NAVIGATION - STALL WARNING HORN REPLACEMENT

This service document provides parts and instructions to remove the original stall warning horn and wiring, install a bracket, new stall warning horn, and wiring.

SEB-34-22
Page 1 of 10

Figure 1. Warning Horn Modification (Sheet 1)

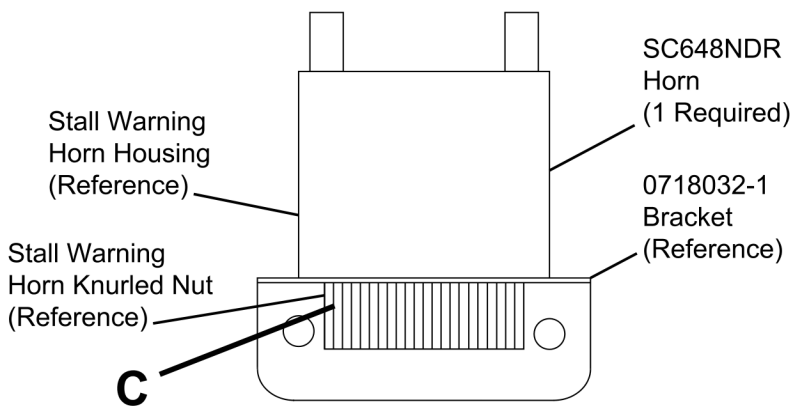
NOTE: Only the lower straight wing root fairing will need to be removed. The wrap around and top fairing will not need to be removed.
3. Remove headliner to access stall warning horn assembly. (Refer to Chapter 25, Interior Upholstery - Maintenance Practices.)
4. (Refer to Figure 2, Sheet 1.) Disconnect wiring connector P1 from JC030.
5. (Refer to Figure 1, Sheets 1 and 2.) Remove two MS21083N08 Nuts and NAS1149FN816P Washers that attach the stall warning horn assembly to the bulkhead. Keep the nuts and washers.
6. (Refer to Figure 2, Sheet 2.) Remove the stall warning horn from airplane.
7. (Refer to Figure 1, Sheets 1 and 2.) Install the 0718032-1 Bracket as follows:

- A. Position and center the 0718032-1 Bracket over the two holes in the bulkhead where the stall warning horn was removed.

NOTE: Position the bracket so there is a minimum of 0.38-inch edge distance for the hole locations.

- B. Match drill two 11/64 (0.171-Inch Diameter) holes in the 0718032-1 Bracket.

- D. Install the 0718032-1 Bracket with two M35206-245 Screws, the kept washers and nuts.

Figure 1. Warning Horn Modification (Sheet 2)

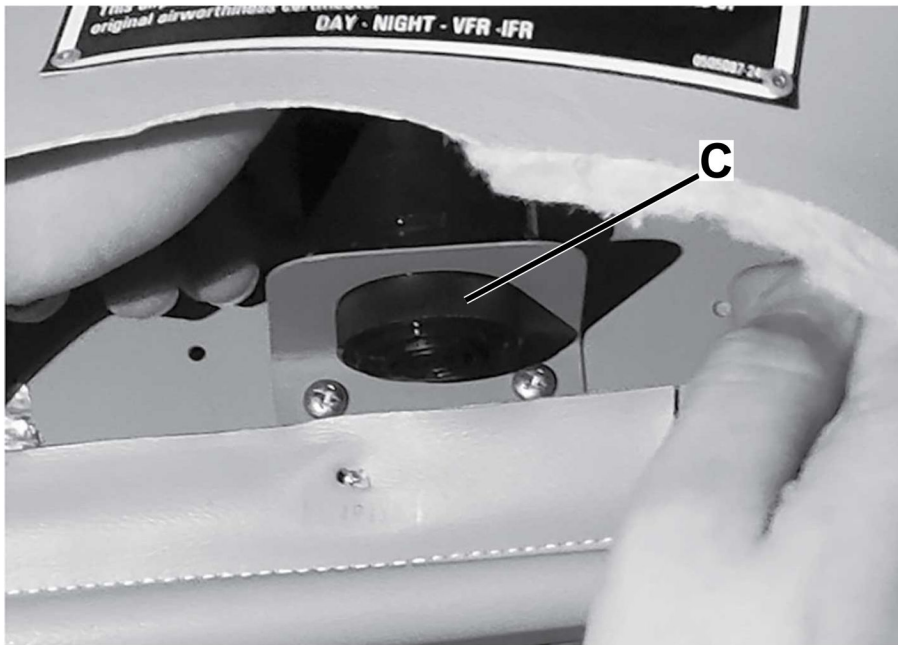
8. (Refer to Figure 1, Sheets 1 thru 3.) Install the SC648NDR Horn as follows:

- A. Remove the knurled nut from the SC648NDR Horn.
B. Put the SC648NDR Horn into the 0718032-1 Bracket.
C. Install the knurled nut on the SC648NDR Horn and hand tighten.

Before Modification, Old Horn

After Modification, New Horn

Figure 1. Warning Horn Modification (Sheet 3)

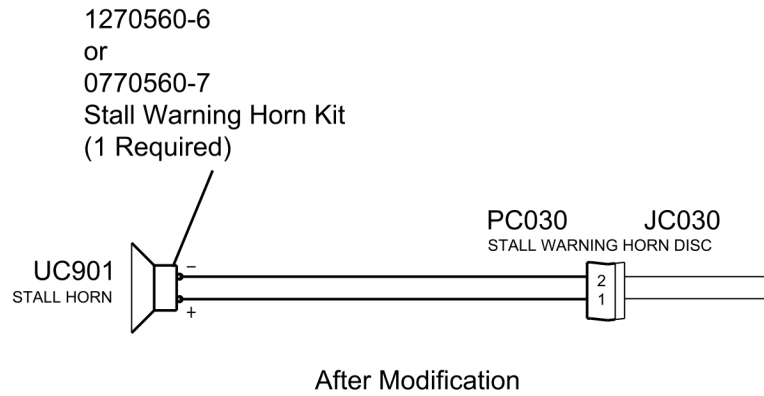
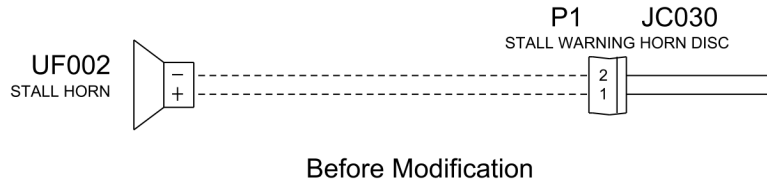
NOTE: (Refer to Figure 1, Sheet 3.) The plastic knurled nut must be installed with the three indents toward the bracket and horn assembly. On the internal circumference, the smooth side without threads is installed first, towards the bracket and horn. This technique of installation will make sure the nut fully seats against the bracket and not bottom-out on the threads. If not installed correctly the knurled nut will bottom-out on the threads and the horn assembly will not be fully tightened in the bracket.

Install with three detents first.
Detents go toward bracket and horn.

Figure 2. Wiring Modifications (Sheet 2)

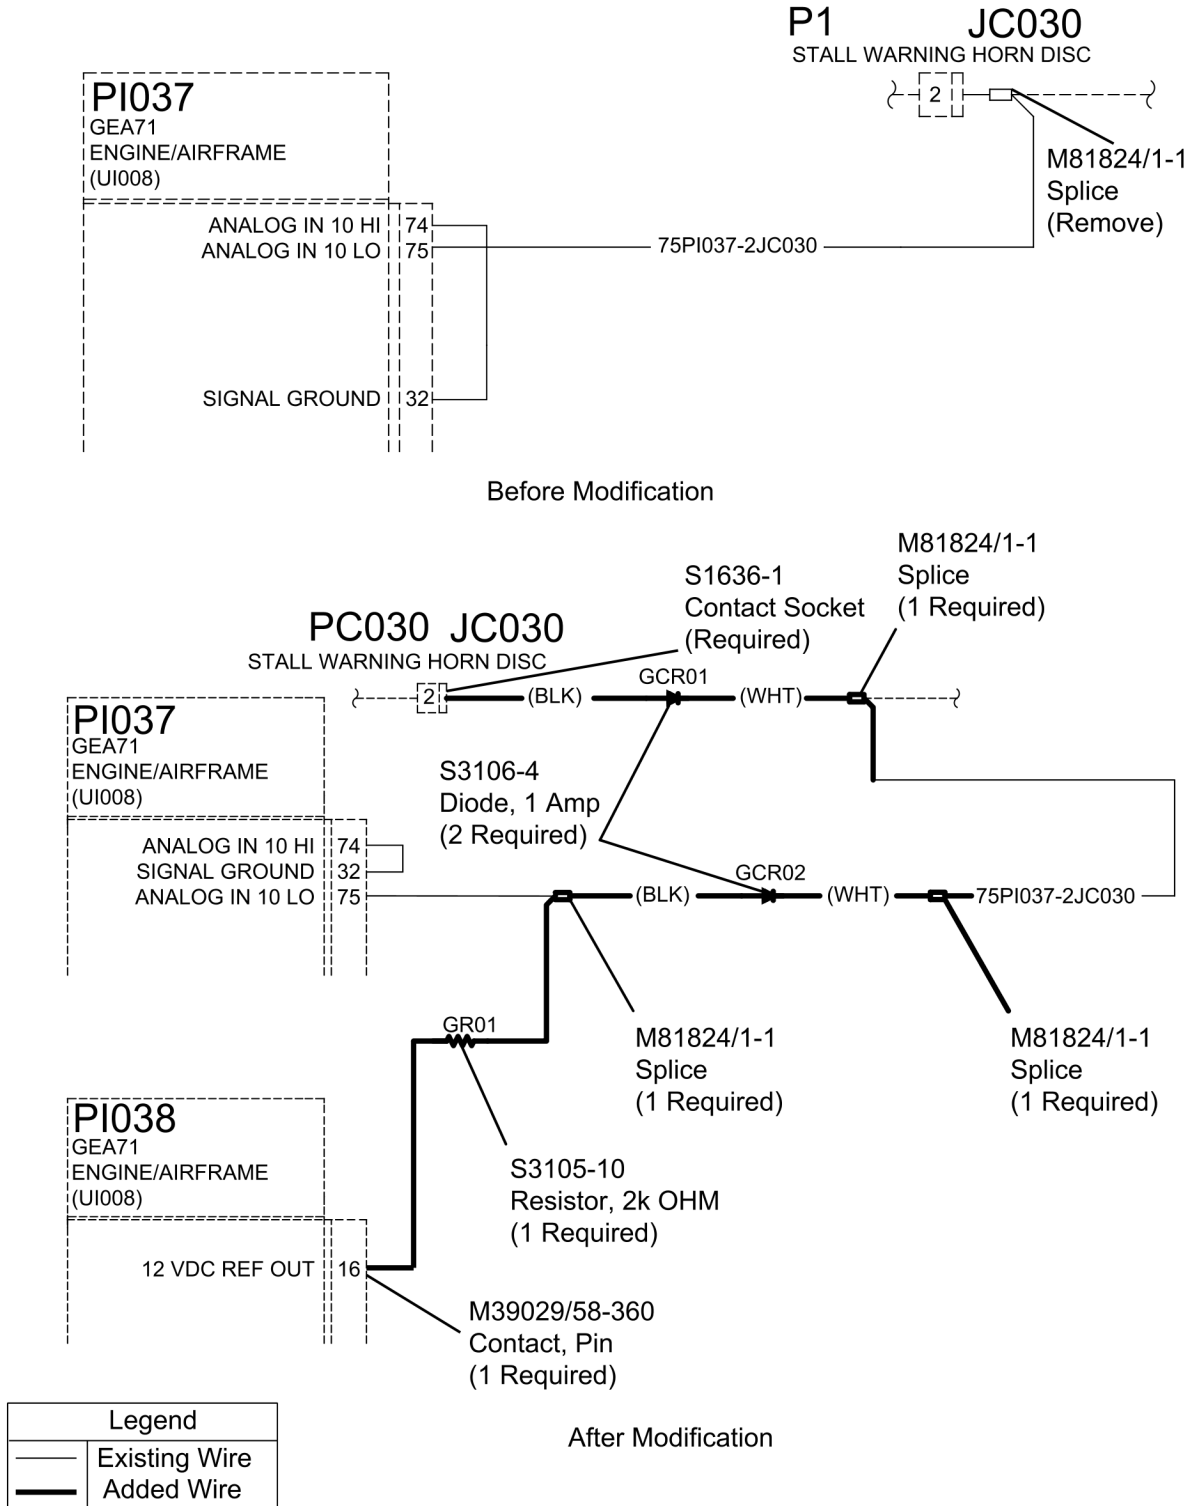
10. (Refer to Figure 2, Sheet 2.) Airplanes listed, do the wiring modification as follows:

- A. Install two S3106-4 2 Diode Assemblies and one S3105-10 Resistor Assembly with M81824/1-1 Splices, S1636-1 Contact Socket, and M39029/58-360 Contact Pin. (Refer to the applicable Model Wiring Diagram Manual, Chapter 20, Splices and Terminals - Maintenance Practices.)

NOTE: The diode and resistor assemblies have sufficient leads to allow butt-splice into the aircraft wiring. Use best shop practices for access, assembly, protection with heat shrinkable tubing, and wire-tie to secure wire bundles after the modification.
